ISSUE:	Permit to Demolish/Capsulate (partial) and Certificate of Appropriateness for alterations and an addition
APPLICANT:	Kai Anton Holdings Inc represented by Philip H Dorsey III
LOCATION:	Old and Historic Alexandria District 221 Gibbon Street
ZONE:	RM / Townhouse Zone

# **STAFF RECOMMENDATION**

Staff recommends **approval** of the Permit to Demolish/Capsulate and Certificate of Appropriateness for alterations, with the condition that the applicant submit detailed window specifications with the building permit that comply with the *BAR Policies for Administrative Approval*.

Figure 4. Architectural plan of proposed one-story addition, as viewed from the east.

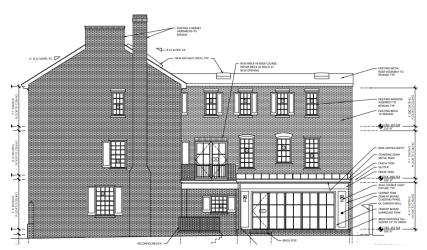
According to the *Design Guidelines*, "The Boards actively discourage the visual disruption of a historic roof profile with a skylight". Staff does not believe that the proposed skylights disrupt the roof profile of the subject property because they will be minimally visible. Figure 4 (below) shows the architectural plans for the one-story proposed addition.

The addition will have a standing seam metal roof and fiber cement siding. The east elevation of the addition will have a set of five aligned multi-light windows, with a panel to either side containing a wall sconce light fixture. The addition will be on top of a new brick base with a brick step.

The *Design Guidelines* also say that "The stylistic characteristics of additions to residential buildings should reflect the historical architectural styles found within the historic districts," and "Additions must be designed so that they are compatible with both the architectural character of the existing house and the immediate neighborhood." The proposed addition to the subject property will be minimally visible so that the architectural details will not be easily seen from the street. Nevertheless, staff finds that the design is compatible with and sympathetic to the style of the rear ell to which it would be attached. While detailed window specifications for the addition were not provided, staff notes that the windows should be made of an appropriate material (i.e. no vinyl). Therefore, staff recommends **approval** of the Certificate of Appropriateness for alterations, with the condition that the applicant submit detailed window specifications with the building permit that comply with the *BAR Policies for Administrative Approval*.
